CERTIFICATE OF APPROPRIATENESS

Property: 711 W. Cottage Street, Lot 14, Block 217, East Norhill Subdivision. The property includes a historic 1,637 square foot, one-story wood frame residence and detached garage situated on a 5,616 square foot interior lot.

Proposal: Alteration – Siding / Window Trim. The applicant has replaced the existing 8.25” wood, rabbited bevel lap siding on the south (front) and east side elevations with 8.25” cementitious wood grain textured lap siding. The wood window trim and soffits were also removed in these areas and replaced with cementitious material.

Recommendation: Denial - does not satisfy criteria 1, 4, 5, 6, 9

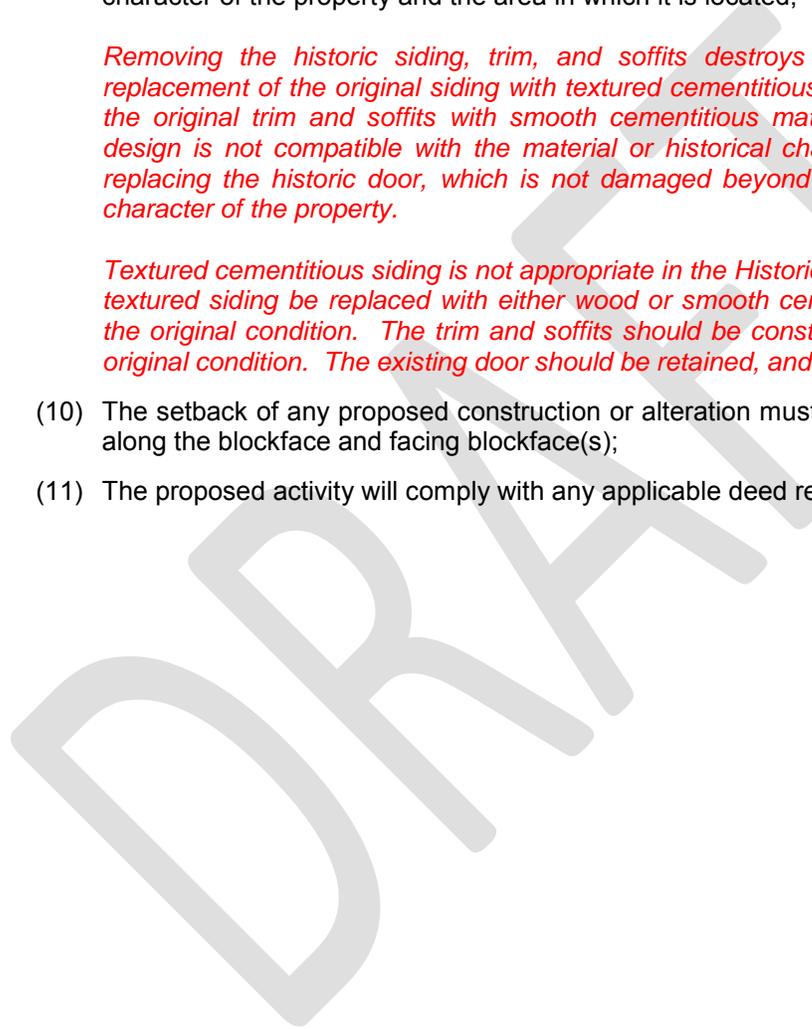
The replacement of the historic trim and soffits with a different, simpler design does not maintain or replicate the distinctive stylistic exterior features that characterize the building, structure.

Textured cementitious siding is not appropriate in the Historic Districts. Staff recommends that the textured siding be replaced with either wood or smooth cementitious slap siding to better match the original condition. The trim and soffits should be constructed and designed as to match the original condition. The existing door should be retained, and, if necessary, repaired.

EXISTING DOOR

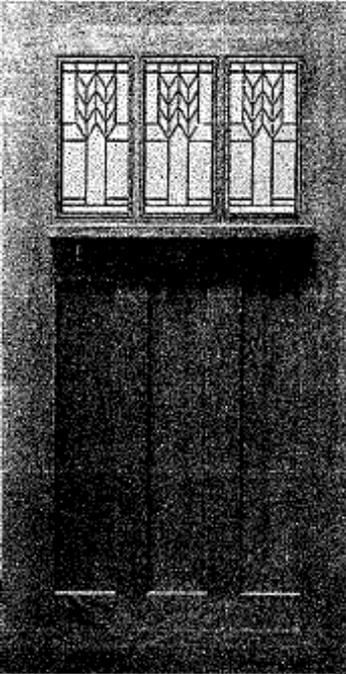
Windows/Doors: The existing residence features a historic divided-lite front door.
The applicant proposes to replace the existing door with a new solid wood Craftsman style door. See drawings and pictures for more detail.
A City inspector visited the site to look at the door and determined that the door was historic and was not damaged beyond repair.

Staff recommends that the trim and soffits should be constructed and designed as to match the original design and condition. The existing door should be retained, and, if necessary, repaired.

POSTED RED TAG

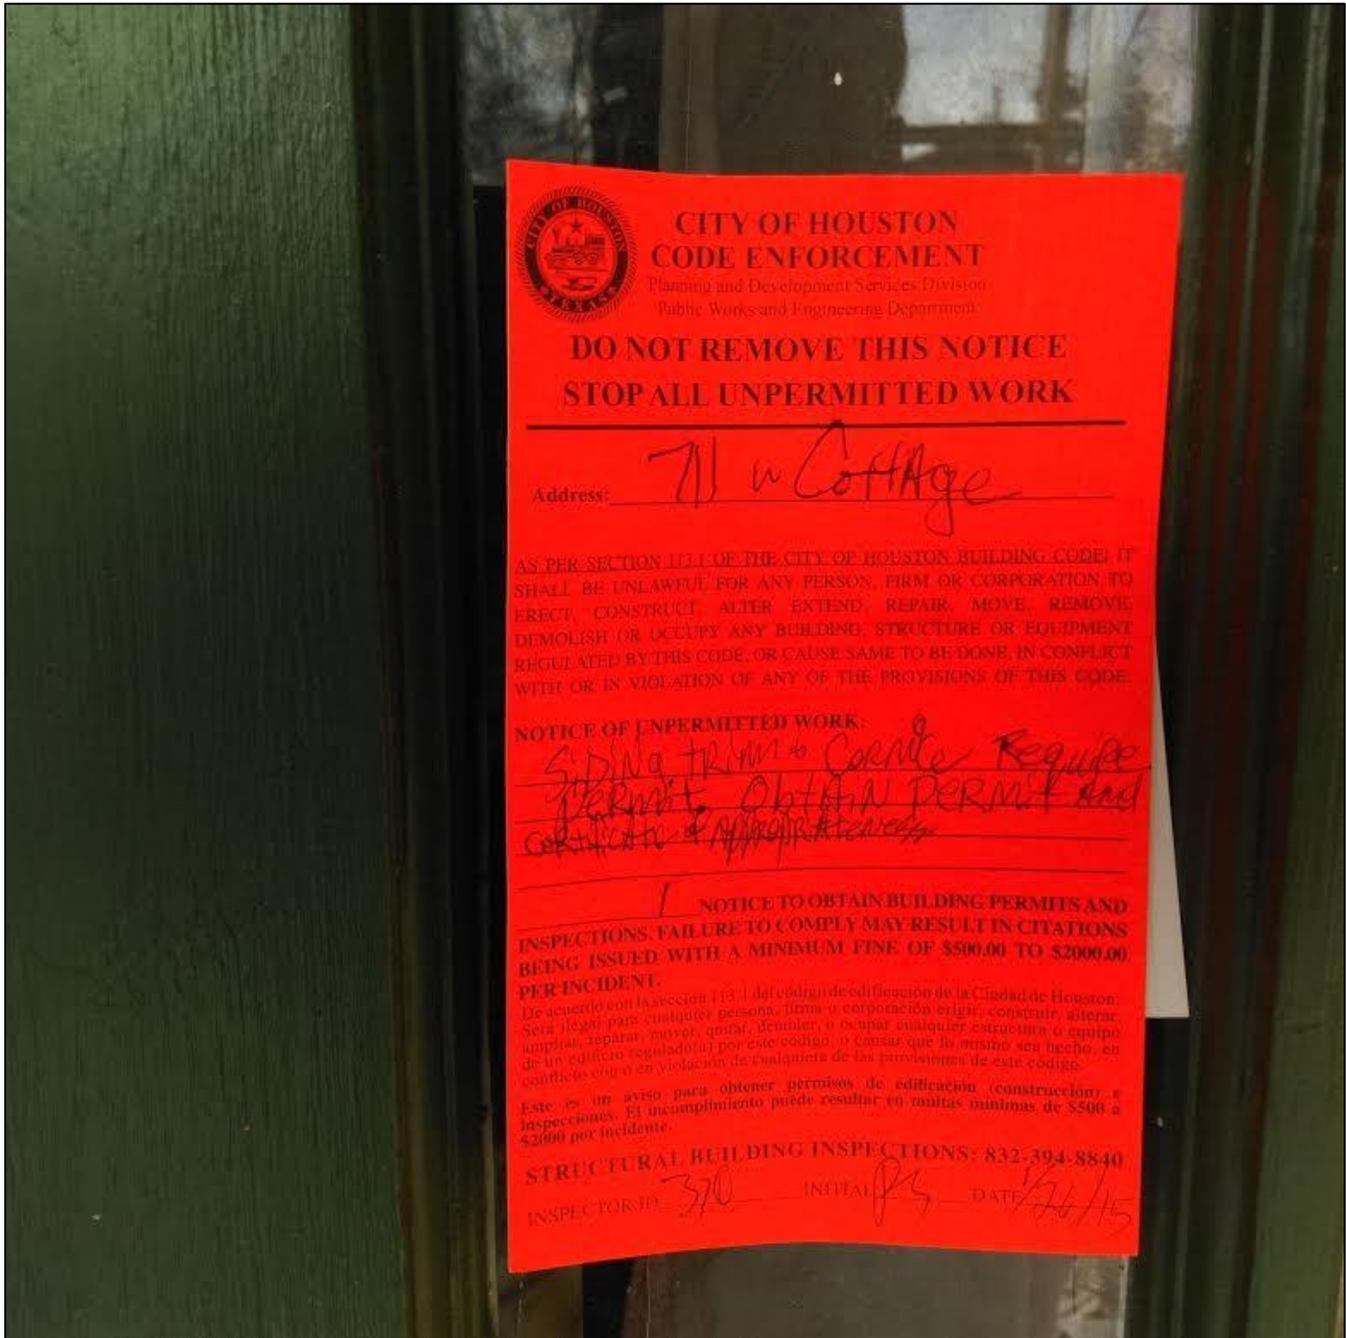
Comment-...	Comment-...	Comment	D...	Dept-Name
01/26/2015	310	BL:1-2-R3-B,STOP UNPERMITTED WORK-OBTAIN PERMITS	430	STRUCTURAL I
01/26/2015	310	1X8BEVEL/LAP WOOD SIDING R&R'ED W/CEMENTITIOUS	430	STRUCTURAL I
01/26/2015	310	REQUIRES PLANNING/HISTORICAL APPROVAL: CALL-77963	430	STRUCTURAL I
